RE: GIANT MINE - RECLAMATION COST REVIEW

REPORT ON
GIANT MINE
CLOSURE COST ESTIMATE

RE: GIANT MINE CLOSURE COST ESTIMATE

Figure 1

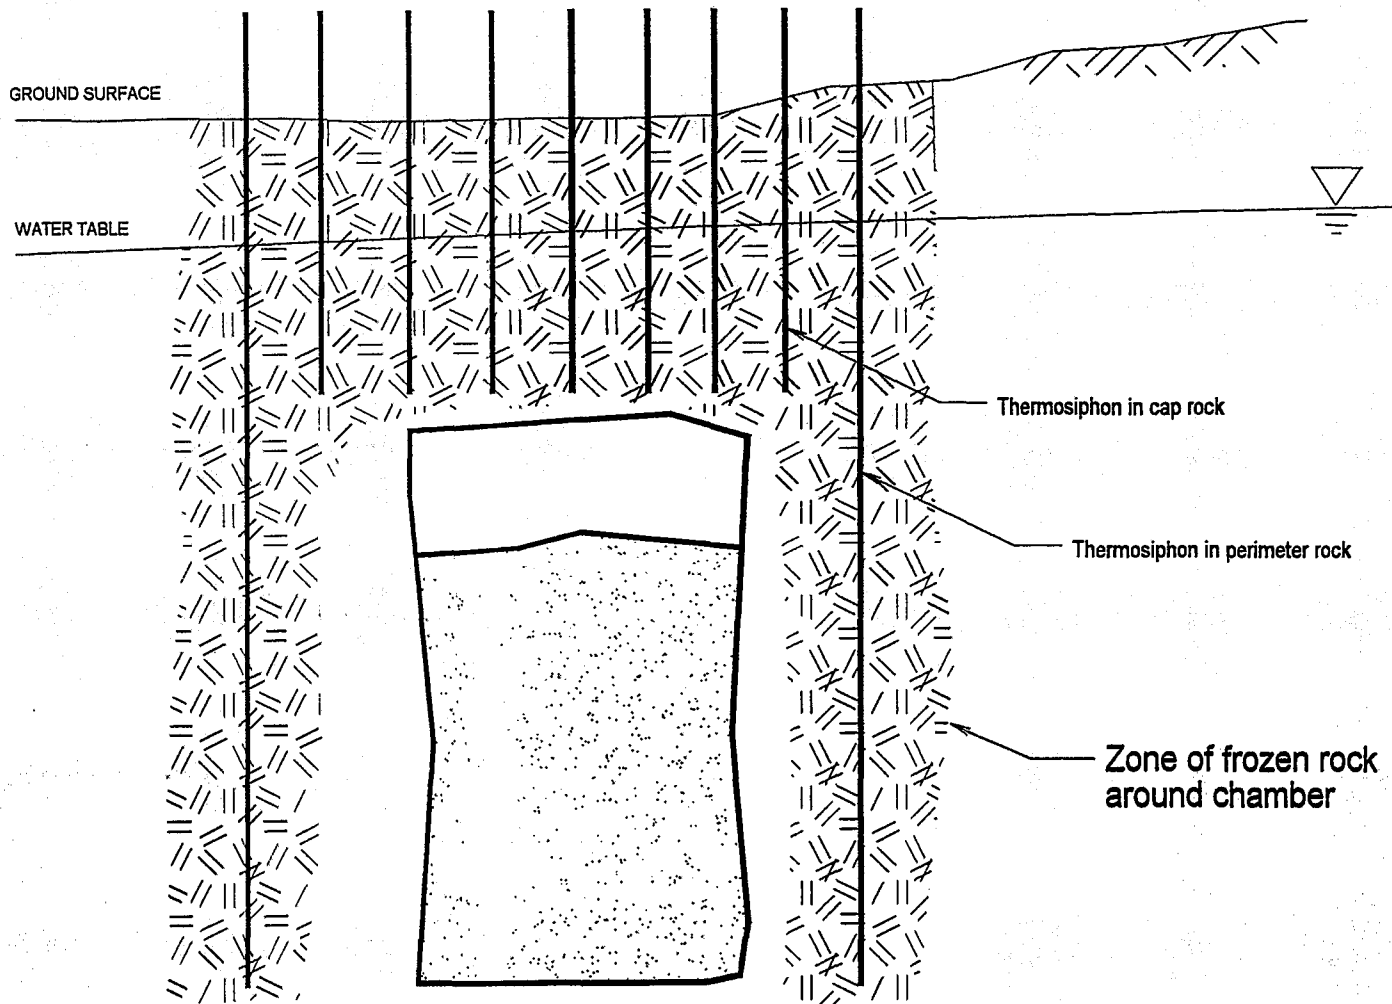
- We can roughly estimate the hydraulic conductivity of the rock around the chambers required to achieve this low level of seepage as illustrated in Figure 1 and as follows; assume the hydraulic gradient into the chambers is 0.05 (1 m head loss in 20 m, which is less than topographic slopes), assume the cross-section area of the chambers is 46 m high by a cumulative length of 533 m, using the formula $Q = -k \times i \times A$ (Q = flow, $-k$ = hydraulic conductivity, i = hydraulic gradient, and A = cross section area through which the flow passes), we find that the hydraulic conductivity of the rock and bulkheads around the arsenic trioxide would have to be $1.35 \times 10^{-11} \text{ m/s}$,

Figure 3

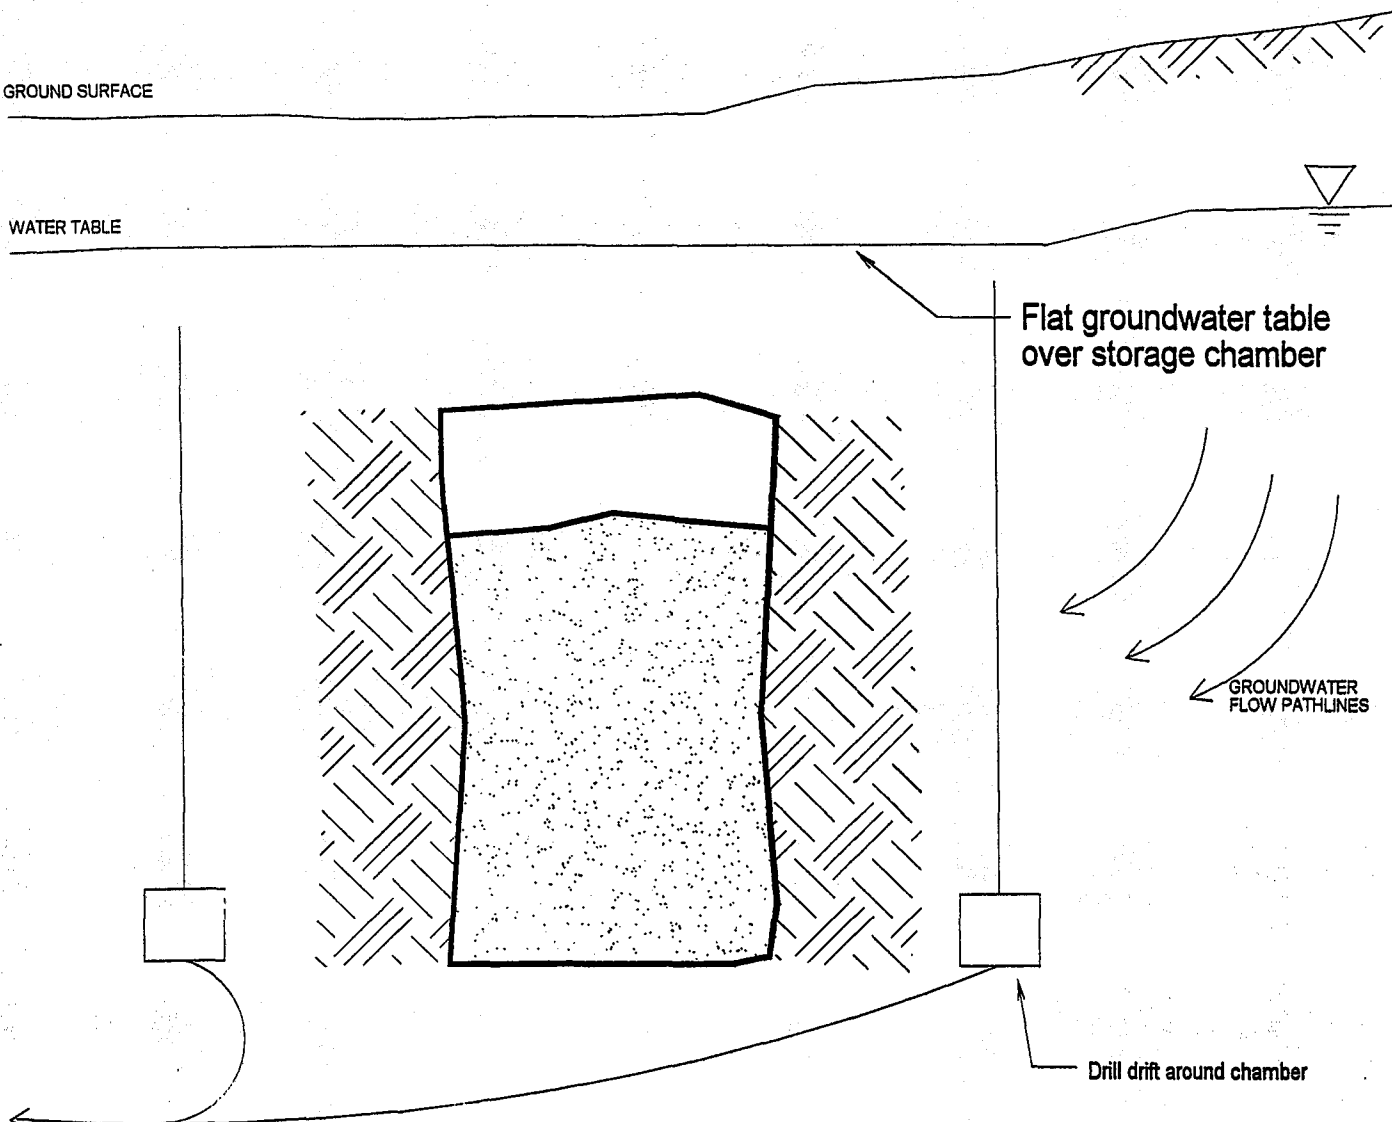
- Thermosiphons could be used to create a frozen perimeter around the chambers and in the ground above them. In this approach, flooding of the chambers would be allowed but release of arsenic would be prevented by a barrier of ice above and around the chambers. Movement of arsenic by dispersion through the unfrozen ground below the chambers would occur, however this process would be extremely slow. This concept is illustrated in Figure 2.
